2-1.2. FUNDAMENTAL MATTERS COMMON TO POWER PLANTS

2-1.2.1. PLANT SYSTEM

FIGURE 2-1 EJECTOR SYSTEM

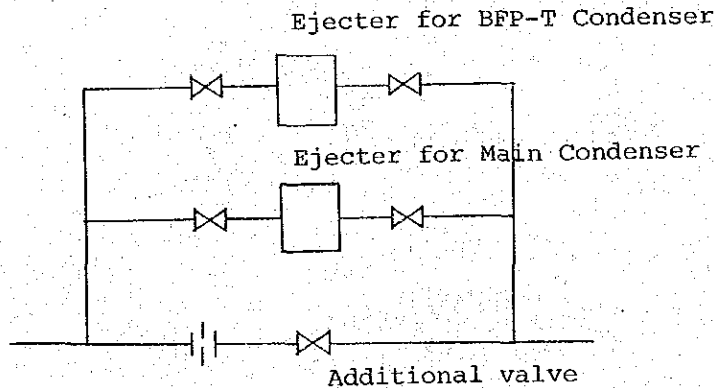
There are experience of overheating of the ejector cooler tube.

- a) Working steam consumption of ejector: Normally constant even if the plant load is lower than rated output.
- b) Condensate flow: Flow rate is proportional to the plant load.

c) The cause of the overheating would be mainly by the less cooling water (condensate) flow in comparison with necessary flow rate for the ejectors working steam at low load operation since the orifice on the main condensate line is not variable one.

For the reasons of a) and b), the orifice must have characteristics as follows:

- in high load: lower differential pressure
- in low load: higher differential pressure

and the actually installed orifice has completely opposite characteristics.

- At least one valve must be added between the branch and confluence point for low load operation.

- In general, the ejectors shall be arranged in series on main condensate line and the condensate minimum flow line shall be led from main condensate line after the gland steam condenser and ejector cooler (before the LP-1 heater) and the minimum flow capacity must be decided on the base of the minimum flow requirement for the gland steam condenser and ejector.

FIGURE 2-2 TURBINE BLED STEAM LINE

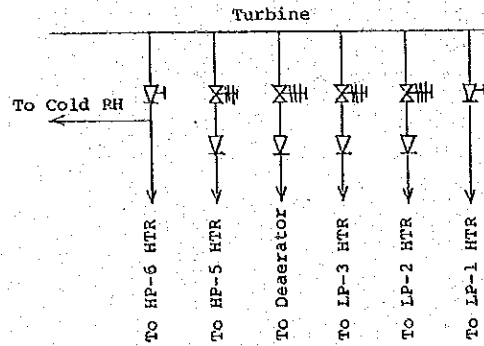
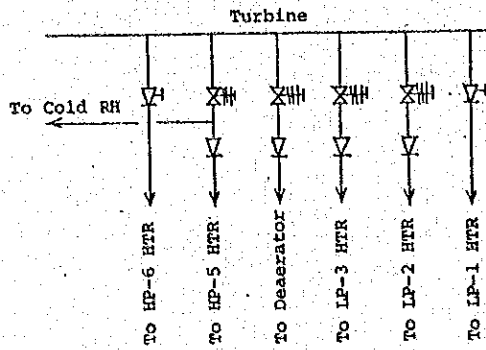
- a) The spring close valve is not able to isolate the line tightly by the spring force and the manual handwheel to close tightly the valve is not so enough large in size.

- b) The valve is not so suitable for bled steam isolating valve.
- c) At least one assist non-return valve having interlock with main turbine interlock systems shall be arranged on each bled steam line.

- d) For deaerator at least one non-return valve and one motorized non-return valve must be arranged since the deaerator has high possibility of water induction by its inherent property even if the bled steam is led into deaerating heater only (different from case of deaerator storage tank).

- e) Preferable arrangement is generally as follows:
(Bled point, etc. will be changed in accordance with each system design and this sketch shows basic idea for reference.)
In case of LP-1, heater is condenser neck heater. If not neck heater, the arrangement will be the same as LP-2.

FIGURE 2-4 CIRCULATING WATER SYSTEM

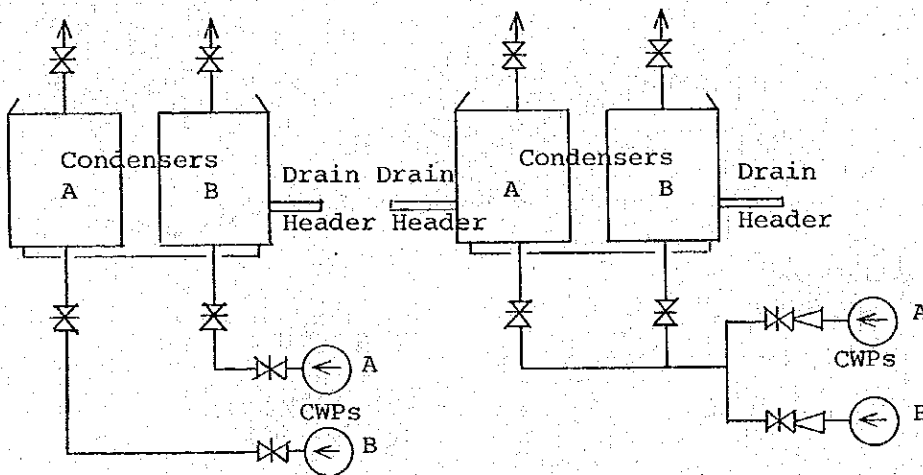
- a) Above existing conceptual arrangement is not adopted to all plants; however, for instance, in case of CWP A/trip, or water box B/tube leak in the above arrangement, the plant is not able to continue its operation.

b) Preferable system:

Even if one of CWP/trip, water box/tube leak, the plant will be able to continue its operation at approximately. 50-60% load of rated output.

c) Separate drain headers divided into both sides of condenser are preferable for balance of condenser cooling.

FIGURE 2-5 ARRANGEMENTS OF CONDUCTIVITY DETECTORS

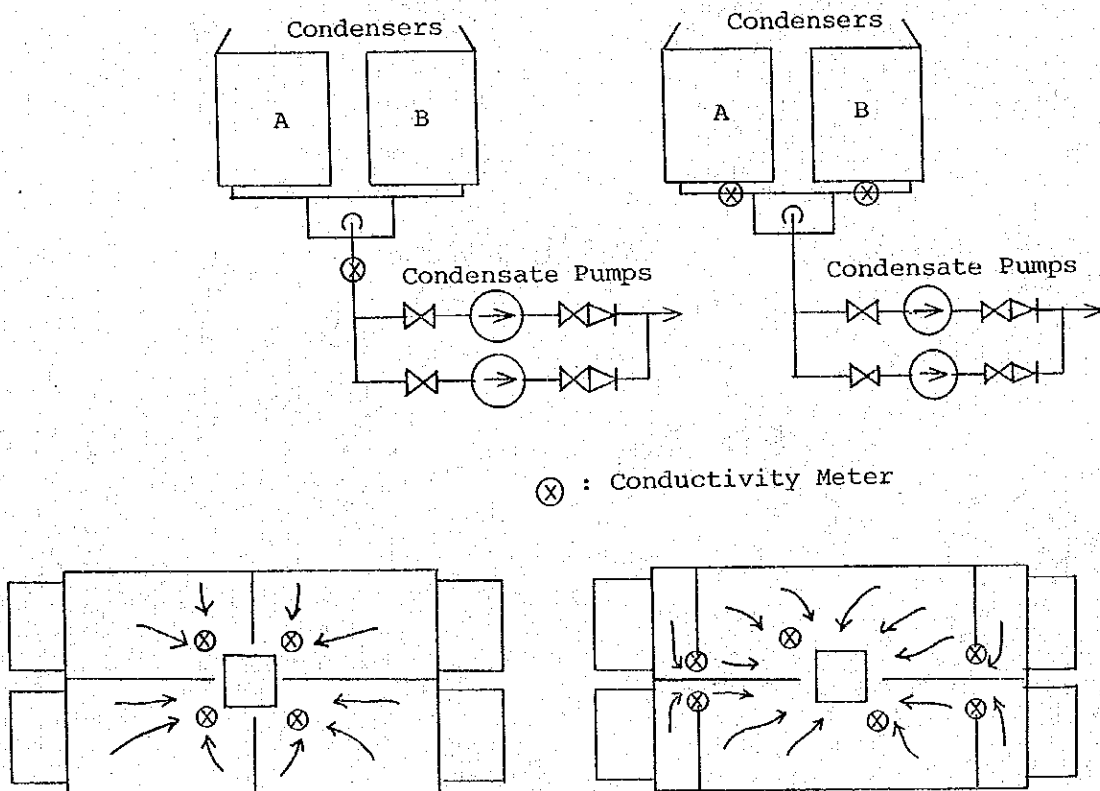
- a) By separate location of conductivity meters, in case of tube leakage occurrence, the leakage side will be identified immediately and operator will be able to put the leakage side out of service without shutdown of the plant.
- b) In the preferable case, each conductivity meter can act as back up monitoring even if one or some of them are out of service.

FIGURE 2-6 BOILER FEEDWATER PUMP

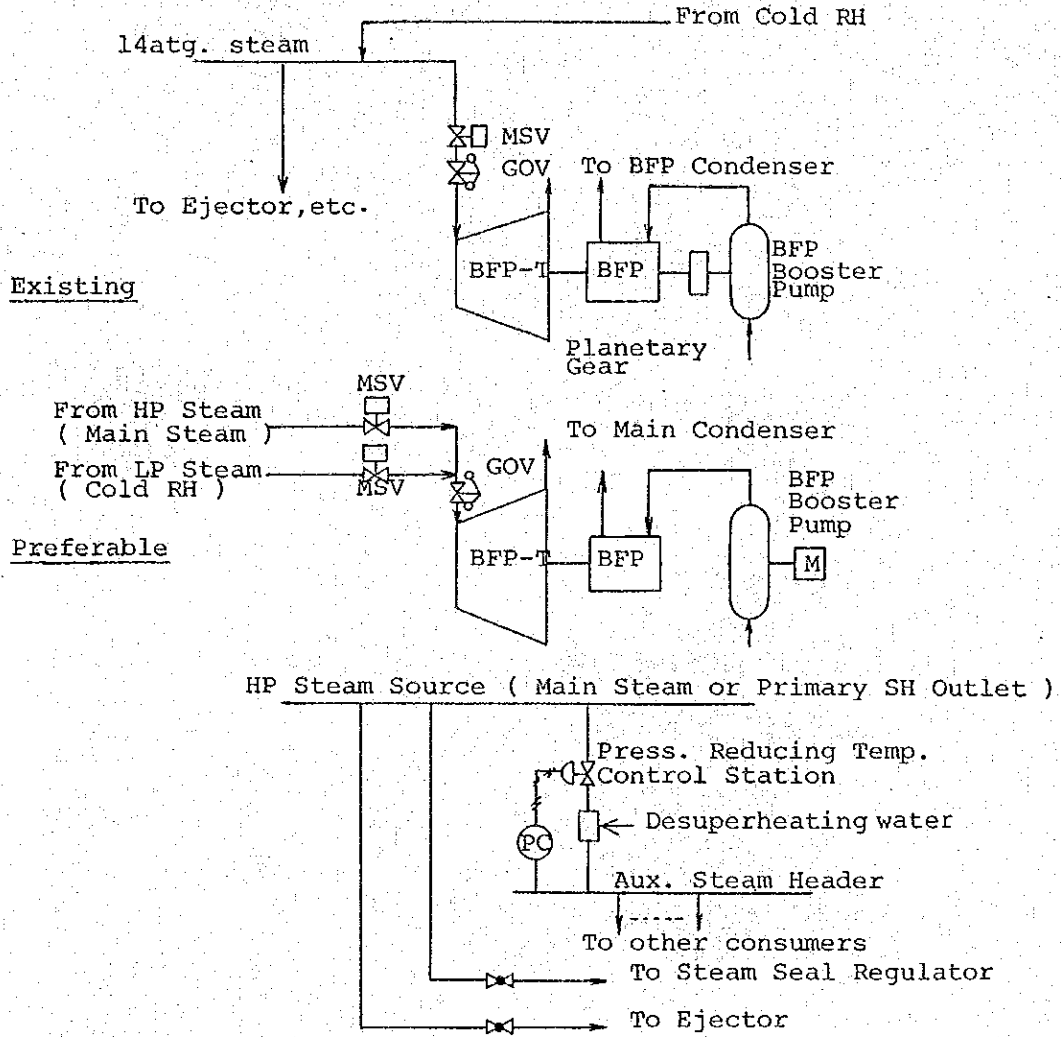
NPSH requirement must be confirmed with the booster pump maker in case of the rearrangement of separate or direct coupling to main BFP since the NPSH depends on the revolution speed.

- a) Back-up system for start-up should be considered.
- b) Auxiliary steam for major equipment and miscellaneous equipment should be separated on the line.
- c) Another motor driven booster pump will be recommendable to eliminate overloading on the planetary gear.

FIGURE 2-7 COMPRESSED AIR SYSTEM

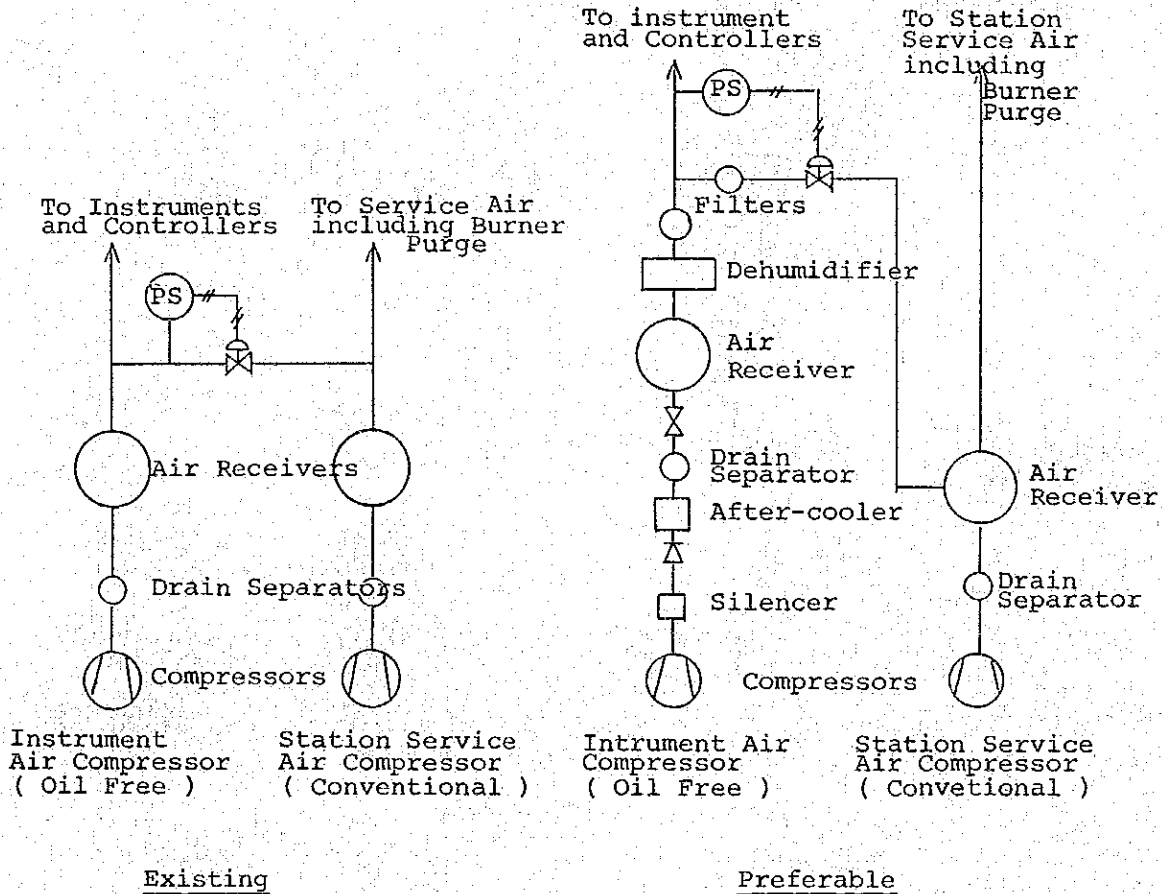
- a) At least separate line from station air receiver (not piping branch) for control air back-up and at least non-return valve should be additionally installed.
- b) Control air unit back-up system will be better than air back-up system from station air source.
- c) Instrument/control air compressor for standby having enough capacity is necessary.
- d) In general, auxiliaries for instrument/control air system, e.g., dehumidifier, filter have not so enough capacity and function.

FIGURE 2-8 DEAERATING SYSTEM

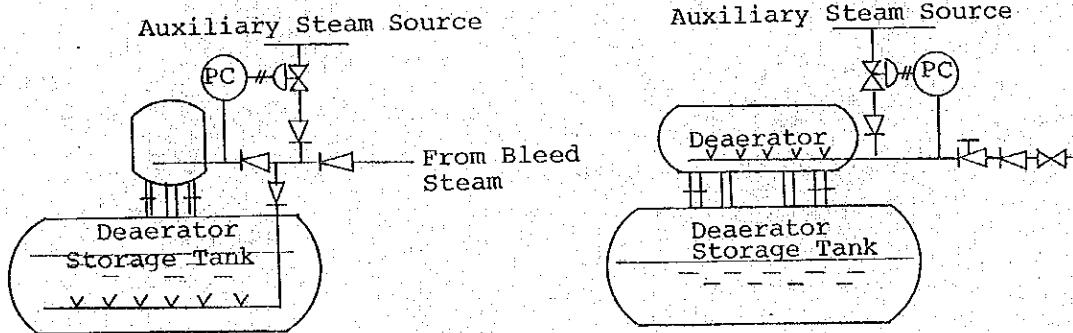
- a) For existing system, at least one non-return valve on each branched pipe will be necessary to prevent water induction to the turbine.
- b) In existing system, operator should take care

especially for the deaerator bled steam system.

- c) Generally, it will be better to adopt the deaerator which does not require the storage tank deaerating and heating.

FIGURE 2-9 DRAINAGE PIPING

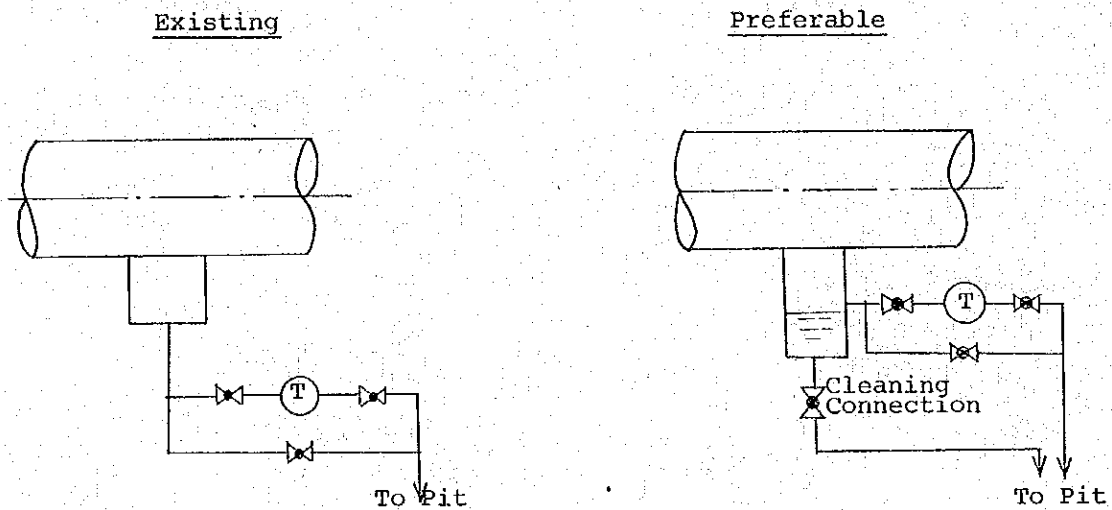
- a) It will be better to provide drain pot with cleaning connection on the bottom, and the ordinary drain will be led from upper portion of the drain pot.
- b) Sufficient drainage piping is indispensable for proper plant operation especially at start-up and shut-down.

FIGURE 2-10 CONDENSATE SYSTEM

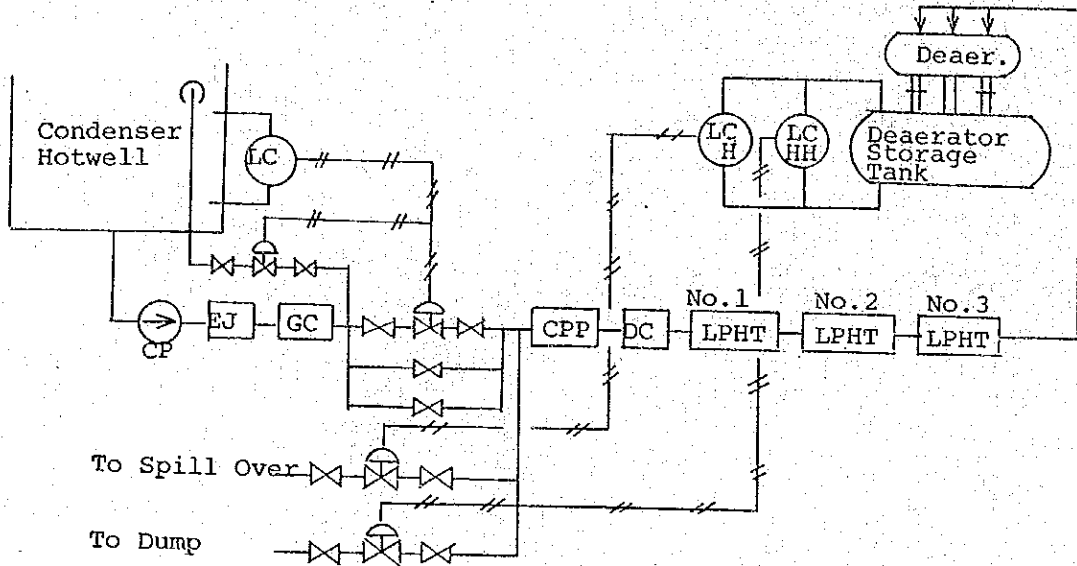
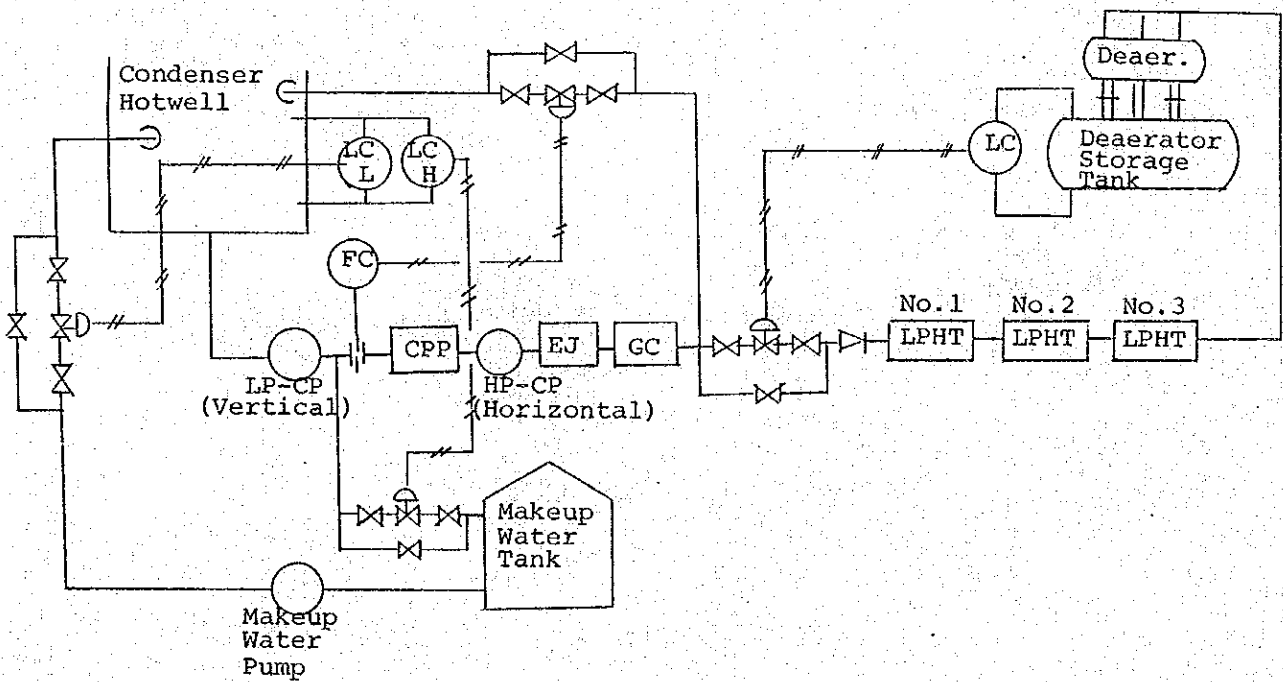
- a) In existing system, the hotwell level control valve looks too big in size; however, every control valve has inherent rangeability, therefore, valve sizing (rangeability should be re-checked) must be re-considered.
Smaller size level control valve may be required for low load operation; however, this arrangement will depend on actual plant loading and the rangeability of existing control valve.
 - b) In that case, cascade control for two control valves will be applicable to the system.
- 10) Start-up/shut-down drainage system around main turbine
A combined drainage device operated by one motor/one arm for several drain valves is applied to the drainage system. This looks very convenient for start-up and shut-down by operating one motor.

FIGURE 2-11 HP HEATER BYPASS SYSTEM

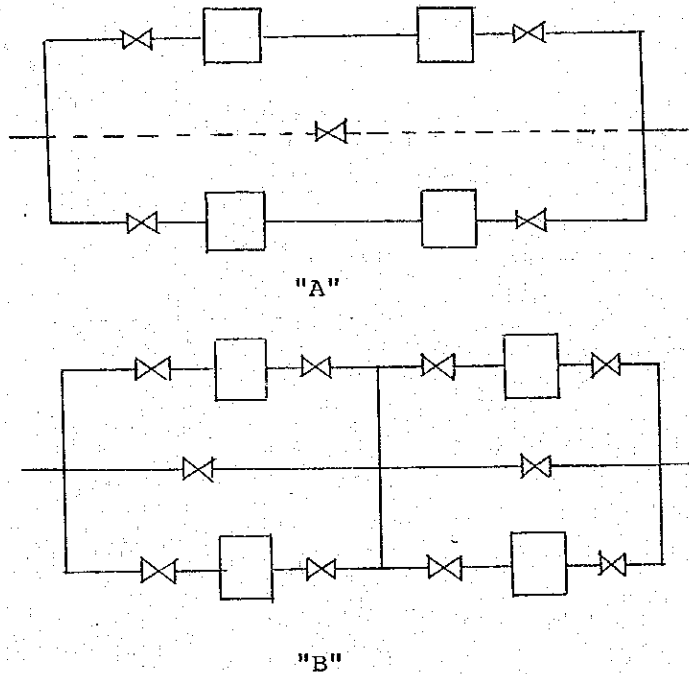
Before the HP heater bypass system has not been provided even if many heater tube leakage troubles occurred.

To prevent water induction from heaters, and to achieve heat recovery (at maximum possible feedwater temperature) in feedwater, arrangement "B" having quick action valves will be more recommendable; however, the kinds of valves will depend on the possibility and tendency of heater tube leak.

All these valves will be very difficult to be operated by manual (big size, high pressure) and air motor or

electric motor driven valve will be recommendable.
